IHSS GROUP SW-2 ORIGINAL LANDFILL (IHSS-115) ROCKY FLATS ENVIRONMENTAL TECHNOLOGY SITE CONSTRUCTION COMPLETION AND CERTIFICATION REPORT

ATTACHMENT A OF THE DRAFT CLOSEOUT REPORT

ACCELERATED ACTION DESIGN FOR THE ORIGINAL LANDFILL

DESIGN OF AN ENGINEERED COVER FOR THE ORIGINAL LANDFILL SHEET INDEX

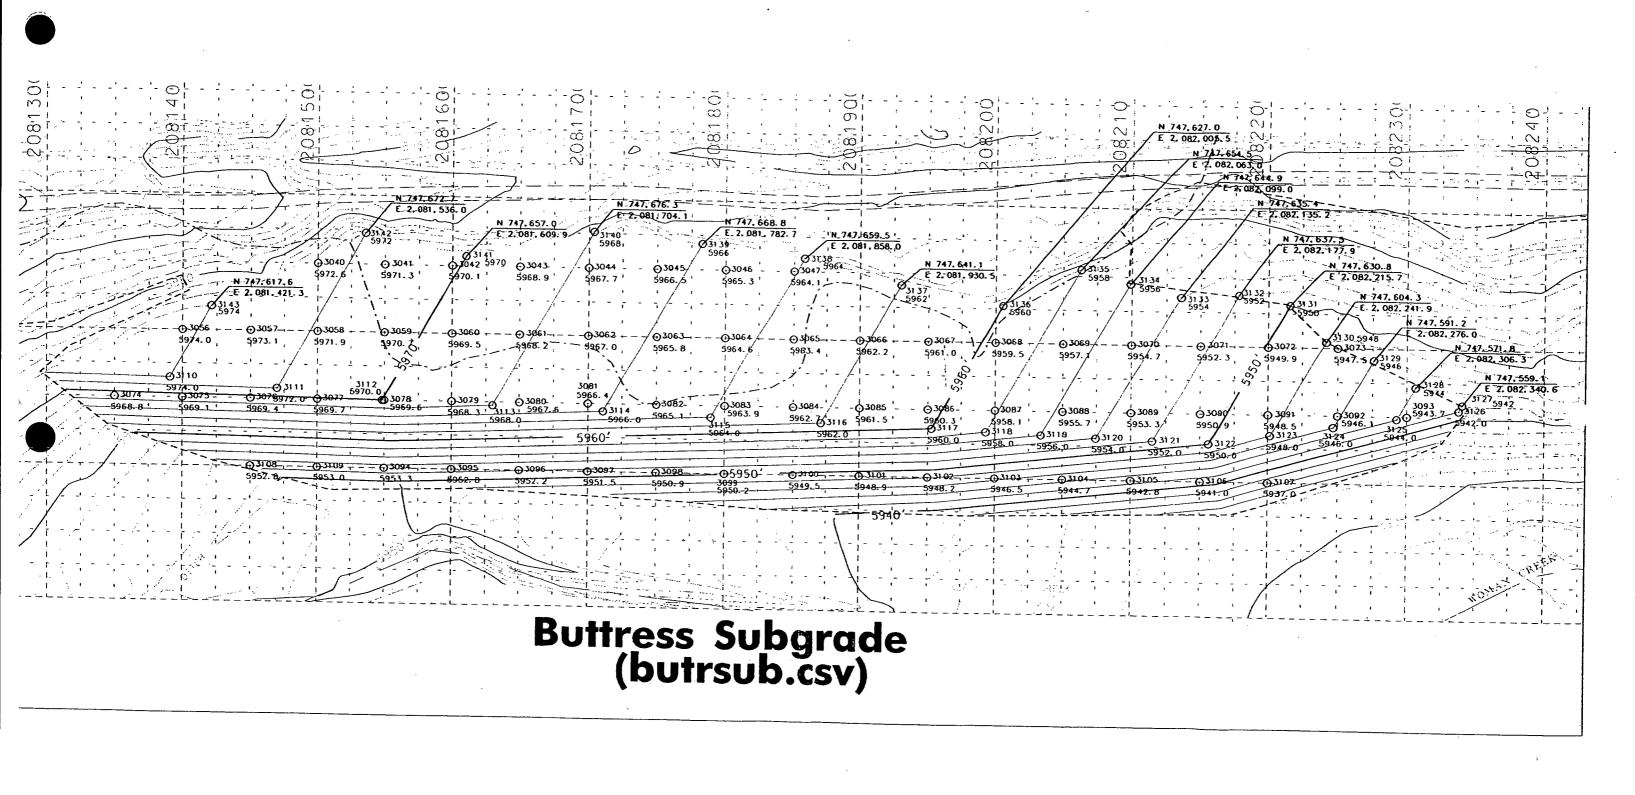
PROJECT JOB NUMBER LOCATION	Cover Original Landfill T0113090 RFETS	RFI NO. PAGE RFI DATE REPLY DATE	009 1 OF 1 6-16-05 6-16-05	
TO SUBJECT DRAWING NO.	RANDY THOMPSON BUTTRESS BACKSCOPE 51788-003	COMPANY LOCATION SPEC. NO.	EMATH TECH ROCKY FLATS OLE N/A	
DUC TO GR CURRENT CON POINTS BASE	REQUESTED: WEBING AND CONTOURING OUTROL FOIRTS MEE NOT FLEW TO ON NEW SURFACE TO E.	ATON DEPEN	BENT, NEED NOW THEYN	
DEVELOP IF R	RED BY 6-16-05 IE PROGRESS OF THE PROJECT EPLY IS NOT RECEIVED BY ABOV REP SIGNATURE		POTENTIAL IMPACT NOTICE X SCHEDULE X LABOR MATERIAL NO IMPACT OTHER	
REQUESTED 1	INFORMATION: Hached control points to			
Please see attached control points to guide the construction of the buttress backshope tie-in. The first set of points (3127-3143) are the design location and elevations of the tie-las. The second set of points (5127-5143) are the same control point locations with elevations reflective of the regade fill. Please provide the Design Tean with cut fill information on these points once surveyed to determine if the intent of Design Diswing OII will be met. DATE DATE

DATE 6/16/05 DATE 6/17/05 DATE COPHE REPRESENTATIVE DATE DATE

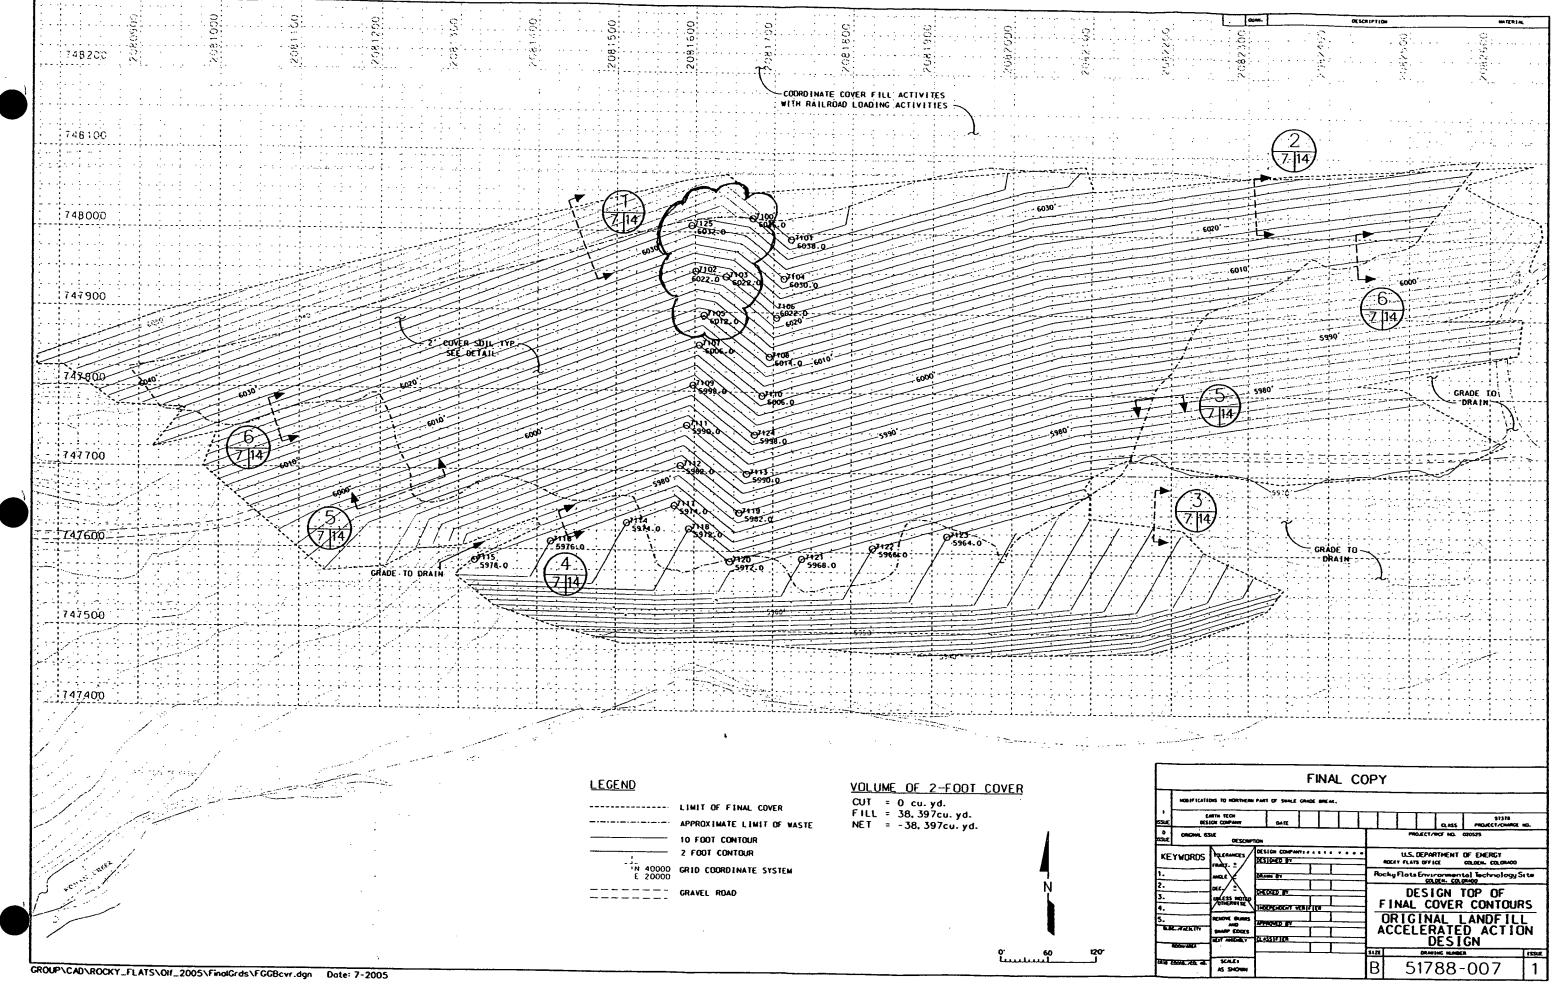
PROJECT	Cover Original Landfill	RFI NO.	010
JOB NUMBER		PAGE	/ OF /
LOCATION	RFETS	RFI DATE	7-4-05
		REPLY DATE	7-7-05
ТО	RANDY THOMPSON		EARTH - TBGH
SUBJECT			OUP-ROCKY FLAT
DRAWING NO	•	SPEC. NO.	<i>N</i> / <i>A</i>
Mes ven	HE GRADE TROAK S ELEVATIONS / COATH FROM FLATIRONS	POL POWYS	BASEP ON AS BULLT
DEVELOP IF F	HE PROGRESS OF THE PROGRESS OF		POTENTIAL IMPACT NOTICE X SCHEDULE LABOR MATERIAL NO IMPACT OTHER
	INFORM	ATION TO CONTRACTO	R
REQUESTED See all end of the over the en grade beak	1. 1 1. 1		od cientours at the north minimum of the feet of coren are control points along all
DM COAE COPHE REP	LA For Rows THOUSEN	DATE DATE DATE DATE DATE

Rocky Flats Original Landfill 7/12/05 Modified Swell/Final Grade Elevations

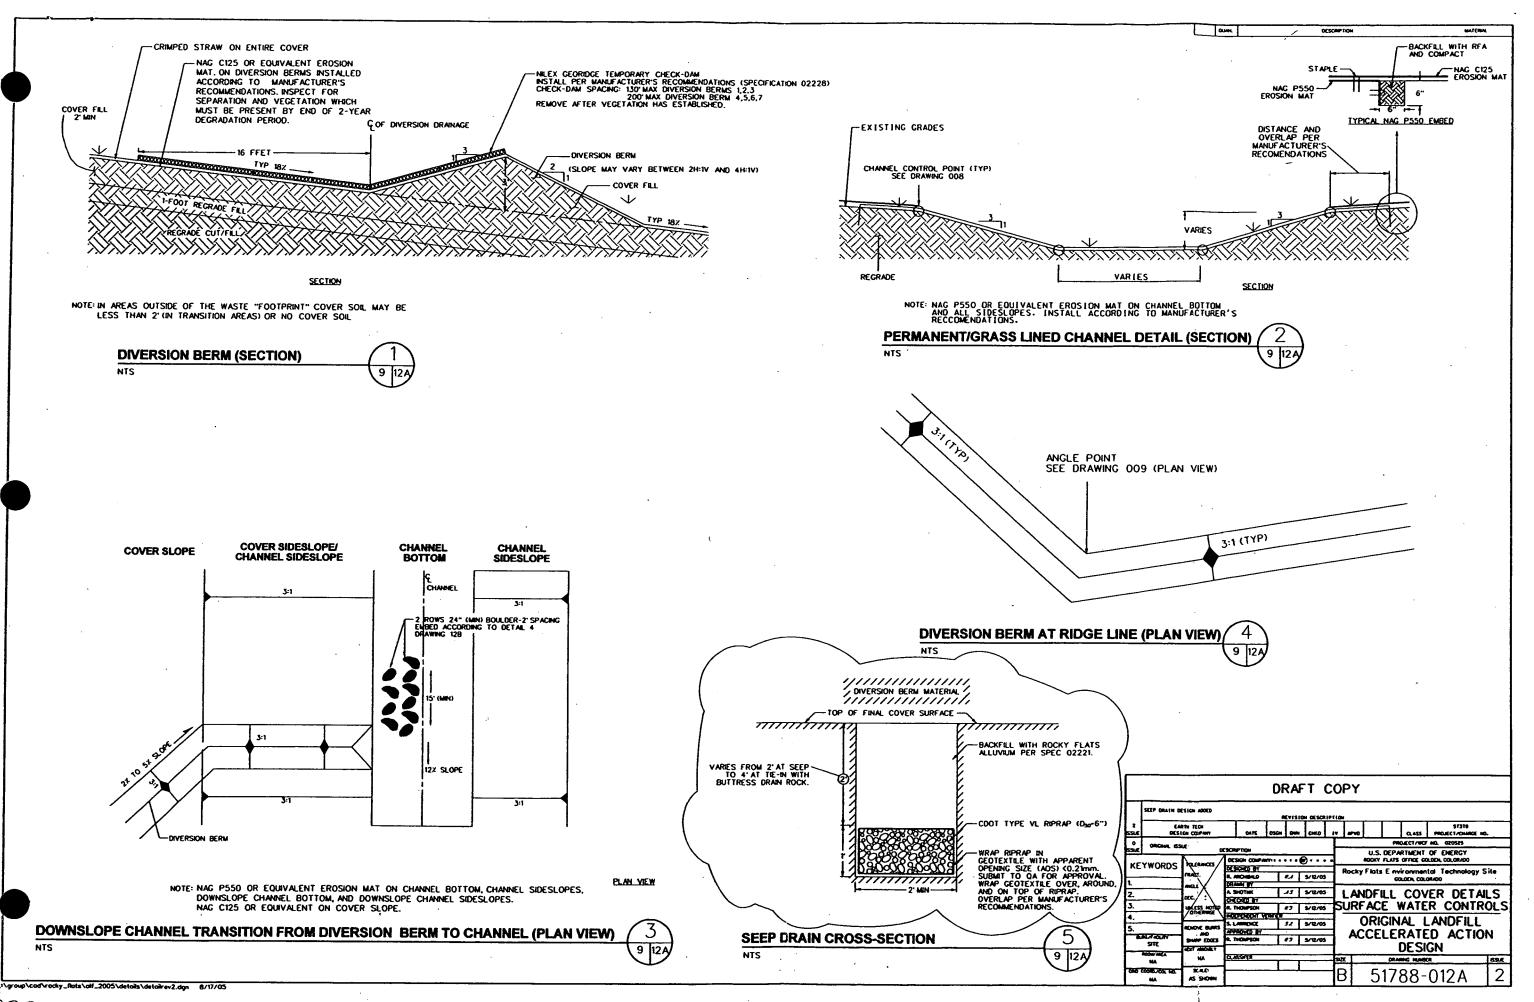
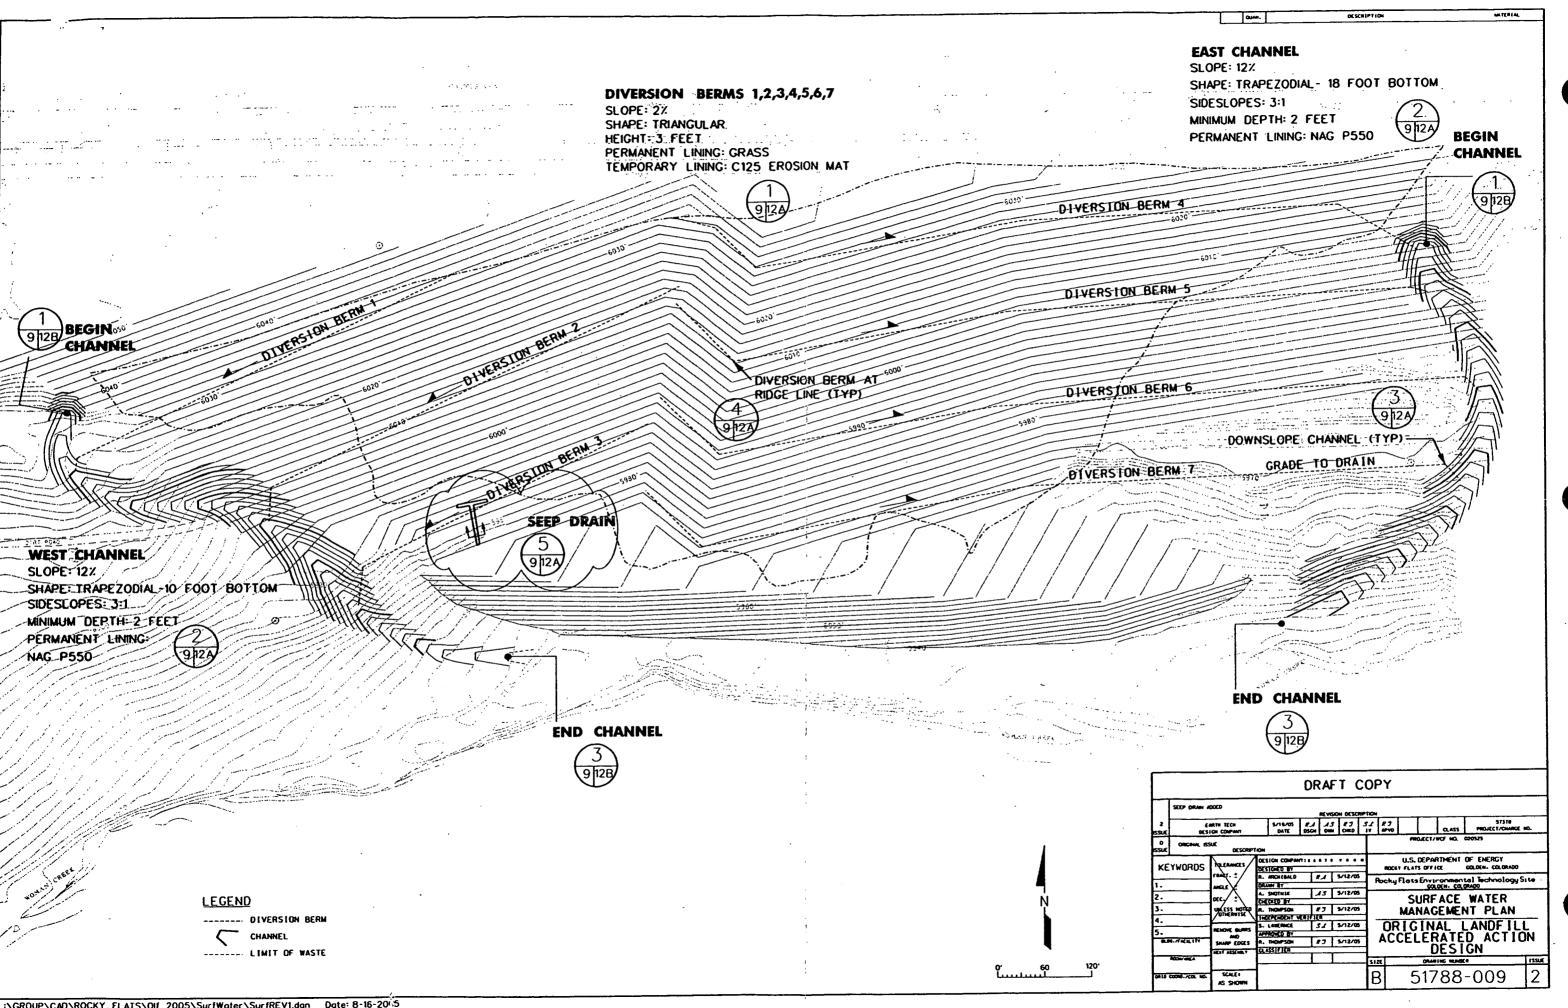
The seep underneath diversion berm 3 may undermine the integrity of the berm, so the water must be drained away from the berm. Because of the seep's proximity to the buttress, the design team recommends draining the water into the buttress drain rock layer, which is designed to handle subsurface flows. Please see the attached design for a T-shaped trench partially filled with 6" riprap wrapped in geotextile to capture the water from the seep and drain it into the buttress drain rock. A plan view of the T-trench drain is presented in Drawing 9 (Issue 2). A cross-section detail of the trench is presented in Detail 5 on Drawing 12A (Issue
